Device TC38x
Marking/Step (E)ES-AE, AE
Package see Data Sheet

10293AERRA

This Errata Sheet describes the deviations from the current user documentation.

Figure 2 Message buffer transfer from Message RAM to OBF

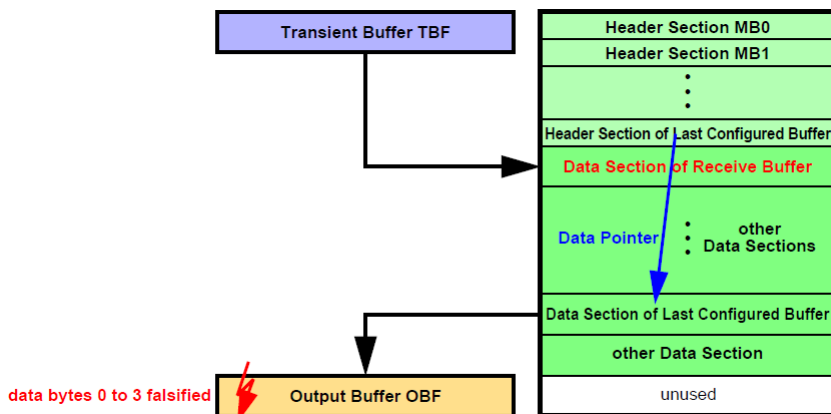
a) When a message is transferred from the Last Configured Buffer in the Message RAM to the OBF and **PLC** = 127 it may happen, that at the end of the transfer the OBF word on address 00h (payload data bytes 0 to 3) is overwritten with unexpected data (see [Figure 2](#)).

Figure 3 Message buffer transfer from IBF to Message RAM

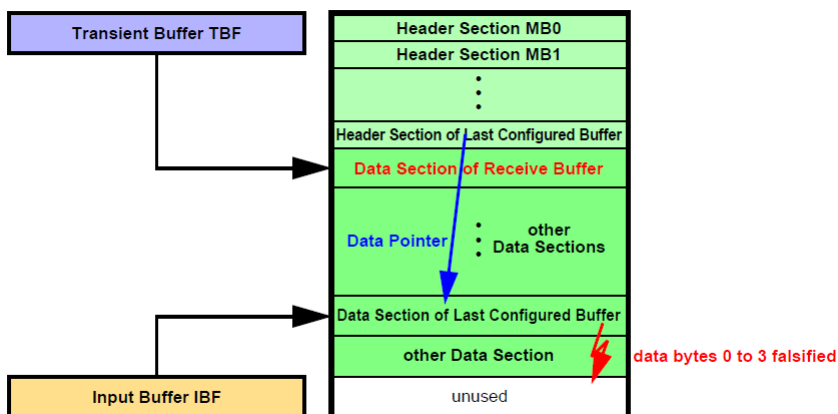
b) When a message is transferred from IBF to the Last Configured Buffer in the Message RAM, it may happen, that at the end of the transfer of the Data Section one additional write access overwrites the following word, which may be the first word of another message's Data Section in the Message RAM (see [Figure 3](#)).

Figure 4 Message RAM Configurations

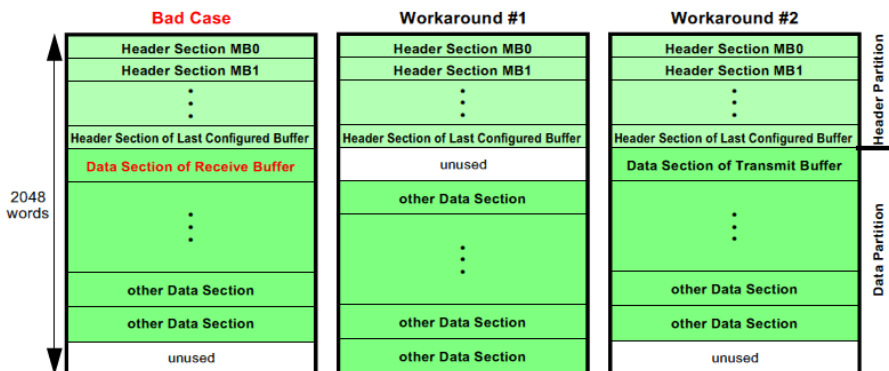
The erratum is limited to the case when (see [Figure 4](#) “Bad Case”):

2) Ensure that the Data Section directly following the Header Partition is assigned to a transmit buffer.

Figure 7 Critical MCS AEI master scenario

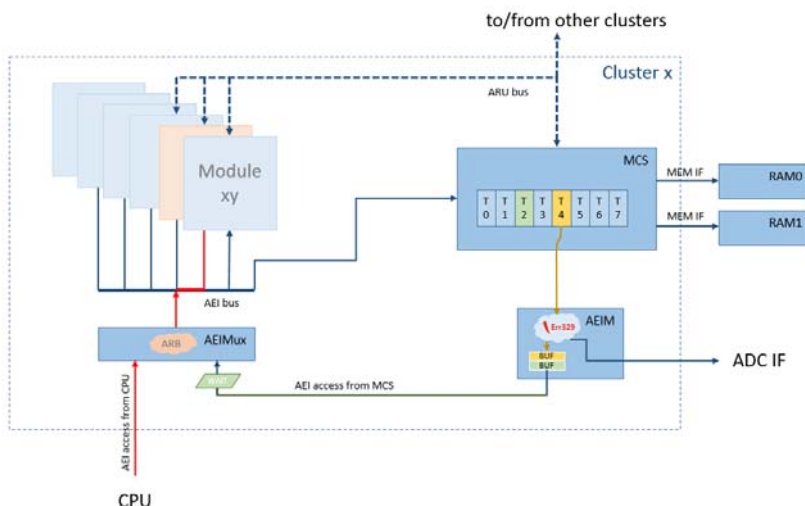
In [Figure 7](#), a potential risk for the occurrence of problem GTM_AI.329 is illustrated. Here the first buffer of the AEIM (green) is still waiting for the access to the AEI bus while a second AEI bus access from MCS arrives at the AEIM (yellow access path). Under certain, but for the user unpredictable timing conditions, this second AEI bus access arriving at the AEIM can trigger the misbehavior described in problem GTM_AI.329.

The workarounds described in the following section will ensure that not more than one AEIM buffer will be filled and therefore the occurrence of problem GTM_AI.329 is avoided. All workarounds have been tested and proven correct.

Figure 8 MCS token mechanism

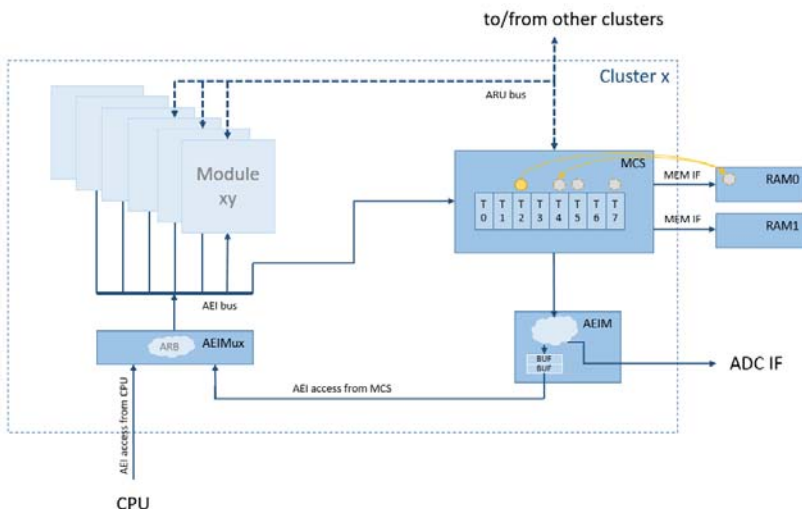
In case multiple MCS channels want to use the AEI master port for AEI or ADC communication, establish a mechanism that ensures that only one channel uses the AEI master at a time (e.g. exchange a token between channels or use trigger registers to hand over the AEI master port ownership between MCS channels).

An application note (AN020 – MCS Mutex implementation) describing a token exchange mechanism between MCS threads is available at Bosch. Such a token mechanism allows multiple MCS threads to safely access the AEI bus system by exchanging an AEI bus access token via MCS memory.

Figure 9 Equivalent Circuitry for Analog Inputs

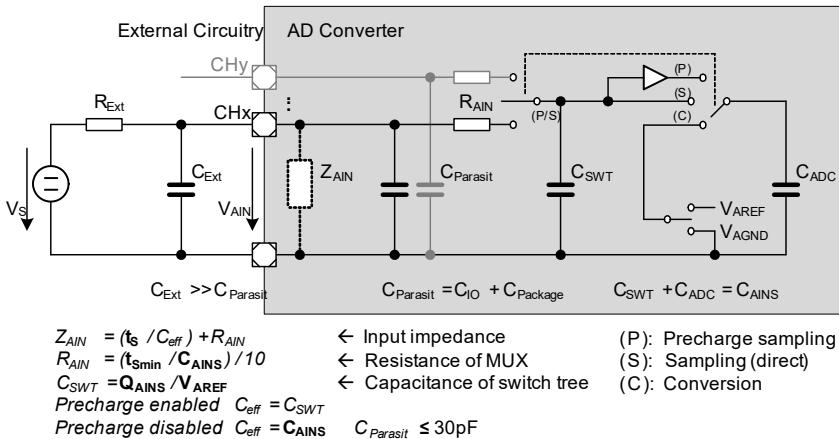
ADC_TC.P014 Equivalent Circuitry for Analog Inputs - Additional information

Figure “Equivalent Circuitry for Analog Inputs” will be modified in future revisions of the Data Sheet, including the term $C_{Parasit} \leq 30 \text{ pF}$, as shown in the following figure:

Figure 10 Interrupt Level vs. Pulse-Notify mode - Corner Case Example

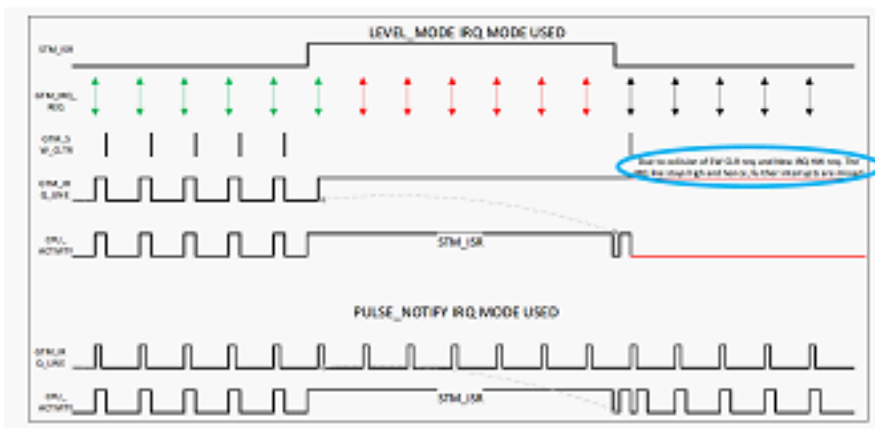
Hence, in Level Mode, in some scenarios where another interrupt request is generated by GTM while the ISR handle also requests a SW clear, then, as the interrupt event is dominant over the clear event (for simultaneous interrupt and clear events), GTM_IRQ_XXX is not cleared and remains high. As a consequence, the IR observes no transition on GTM_IRQ_XX. Thus, any forthcoming interrupt events in this scenario are lost as there is no chance to release the CPU IRQ when a collision happens as shown in Figure below.

If Pulse-Notify mode is selected, every internal trigger will be forwarded to the IR, irrespective of the time of occurrence and the clear event, as the pulse-notify leads to set and reset of GTM_IRQ_XXX as compared to only setting of the GTM_IRQ_XXX line in Level mode.

Figure 12 Timing of LVDS TX interface command sending in relation to IRQ.IFCFS

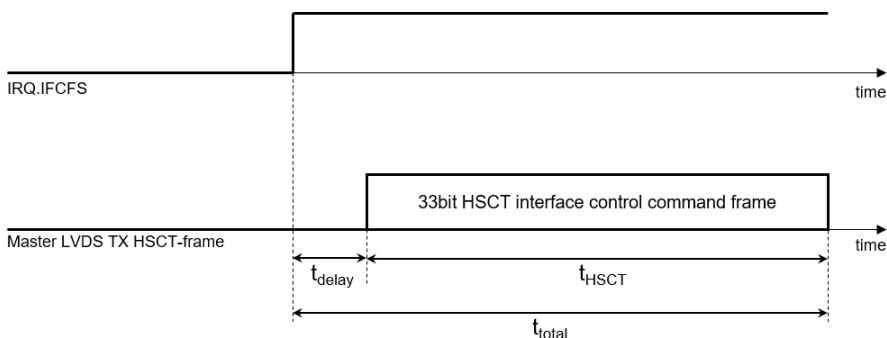
the user might falsely assume that also the actual sending on the LVDS TX port has already occurred once the IRQ.IFCFS flag is set, which is not true.

Instead the timing shown in **Figure 12** applies.
